TERRAMATRIX Inc.
ENGINEERING AND ENVIRONMENTAL SERVICES
 1475 Pine Grove Road, Suite 109
 P.O. Box 774018
 Steamboat Springs, Colorado 80477
OFFICE - (970) 879-6260
FAX - (970) 879-9048

Daron/Bob - Attached are revised text pages, tables, and copies of sections from the revised permit map (Map 4) reflecting the agreed upon revisions. We are forwarding hard copies to update your permit sets via UPS Overnight tonight. Please call with any questions -

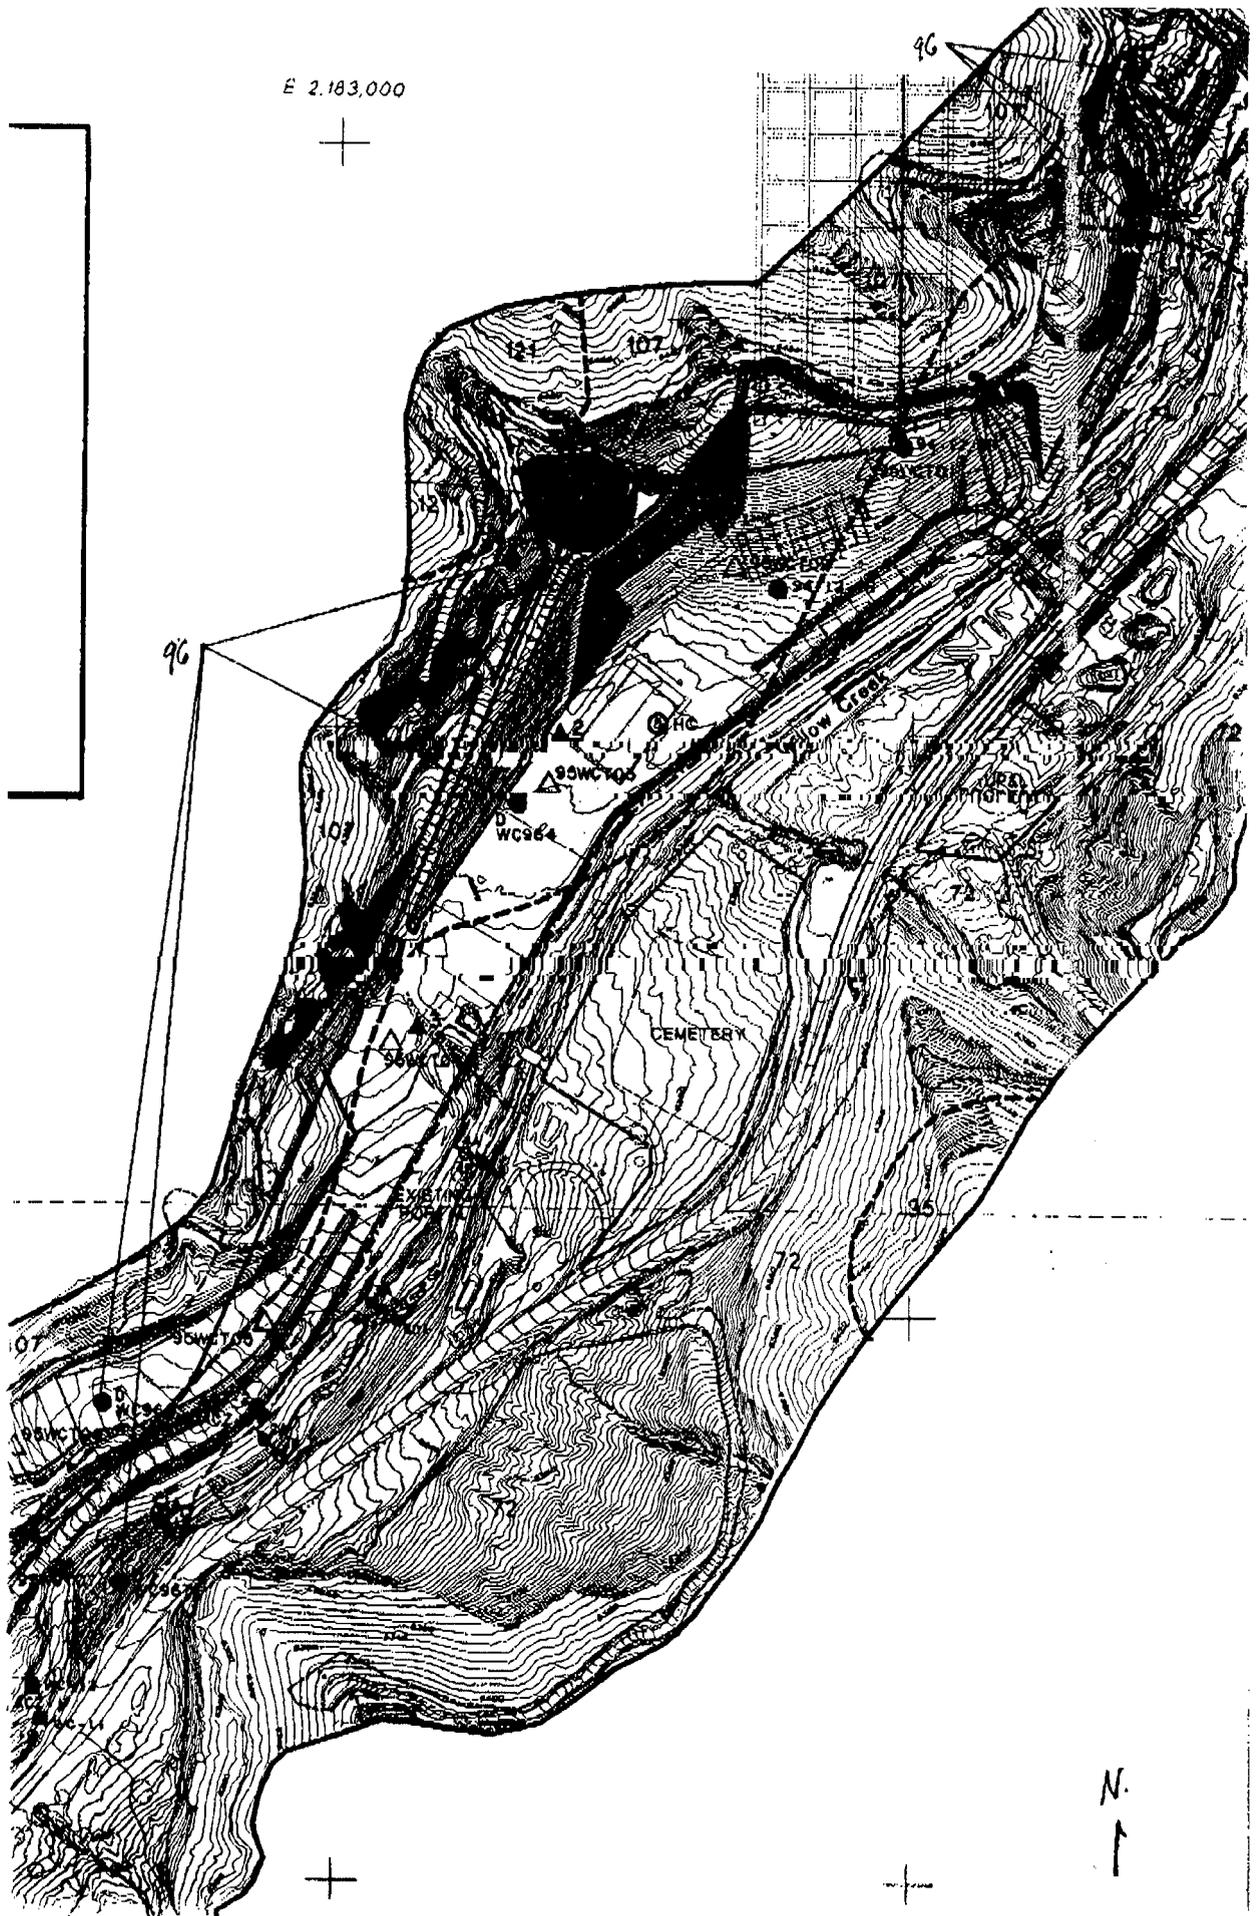
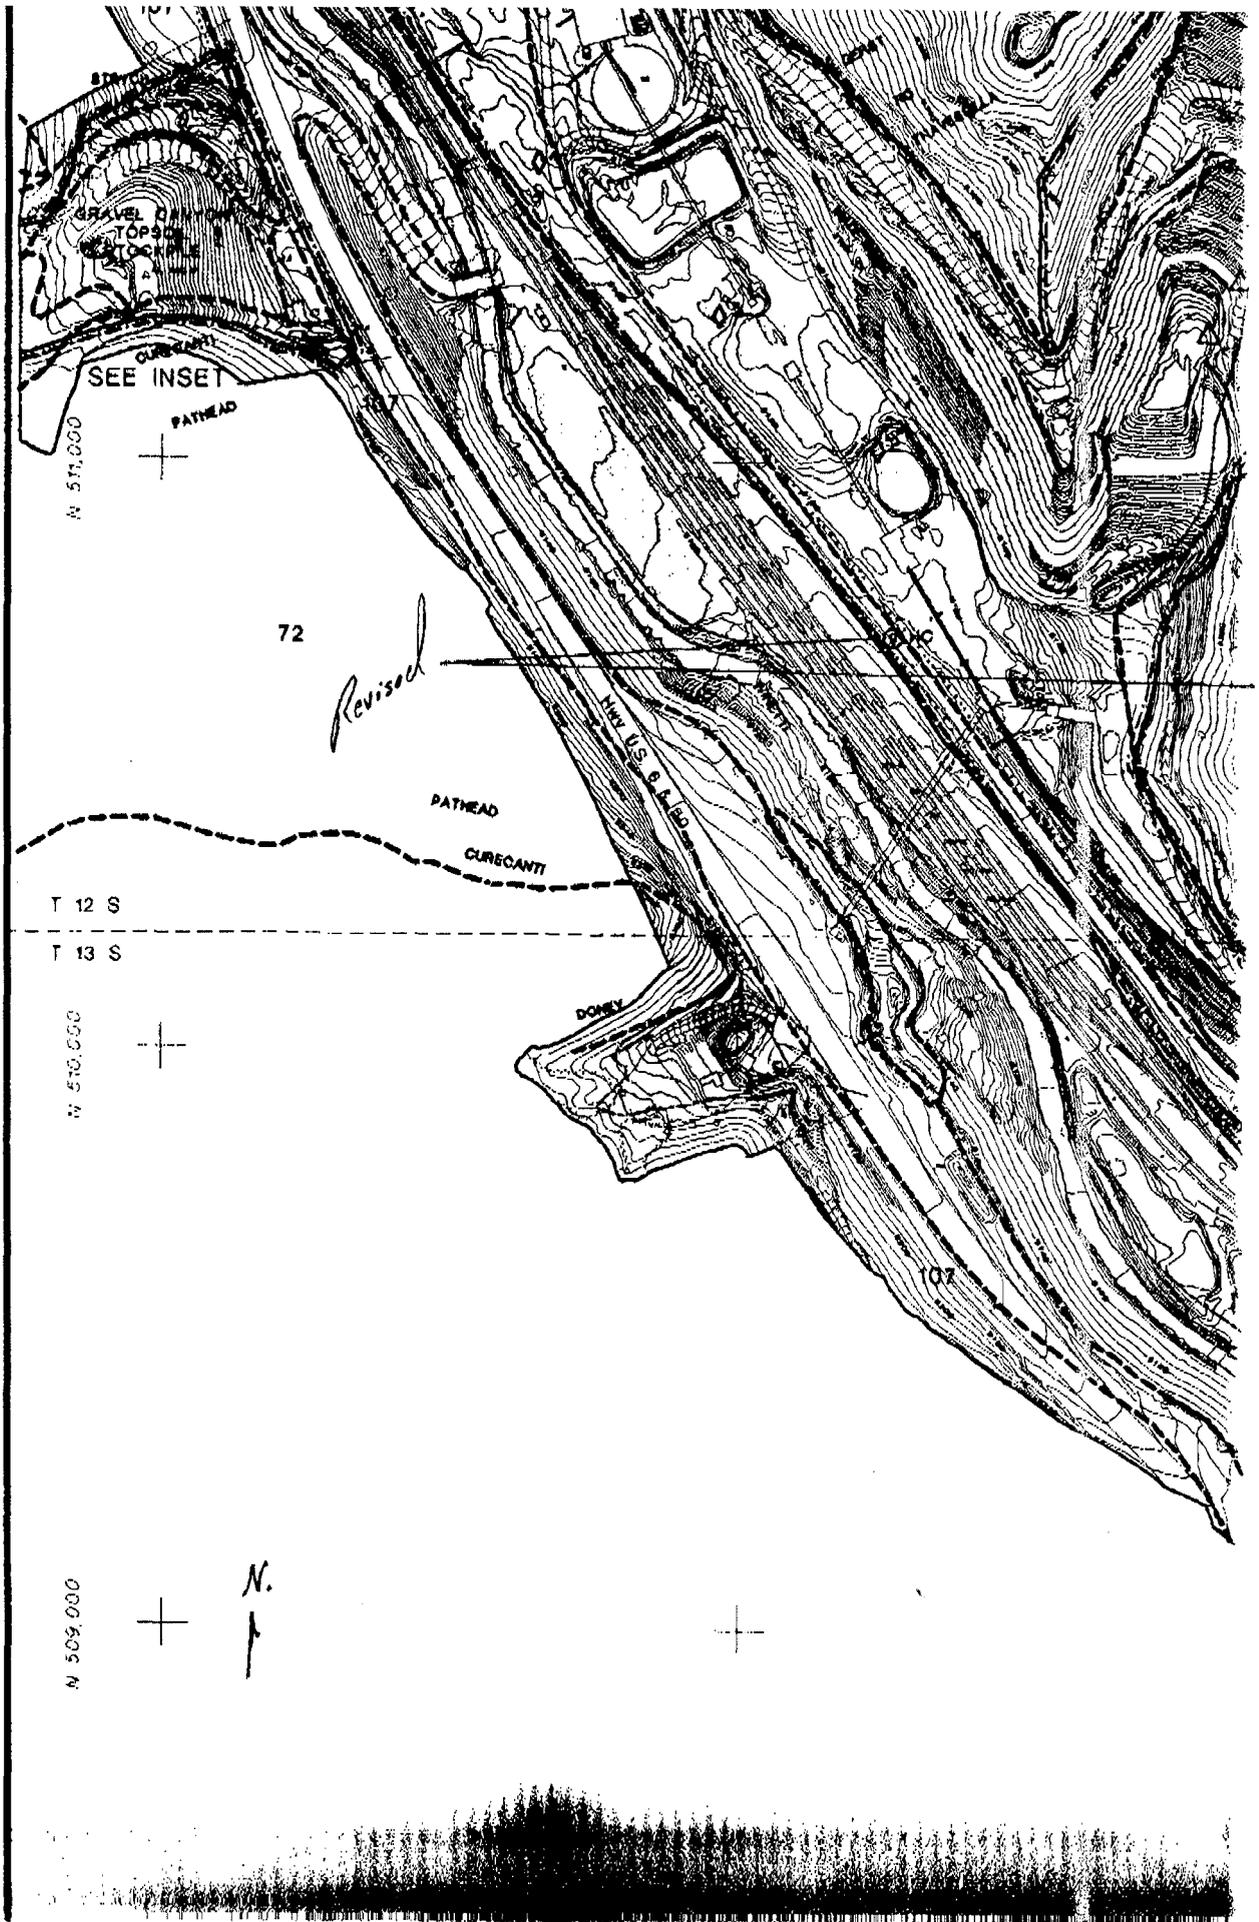
- **1996 Soils Sampling Program** - The 1996 soils survey effort was initiated to address UDOGM Technical Adequacy Concerns. The sampling program involved excavation of 12 additional soils pits and collection of soil samples from 11 of the pits. The locations of the 1996 soils pits are shown on the Facilities Area Soils Map, (Map 4).
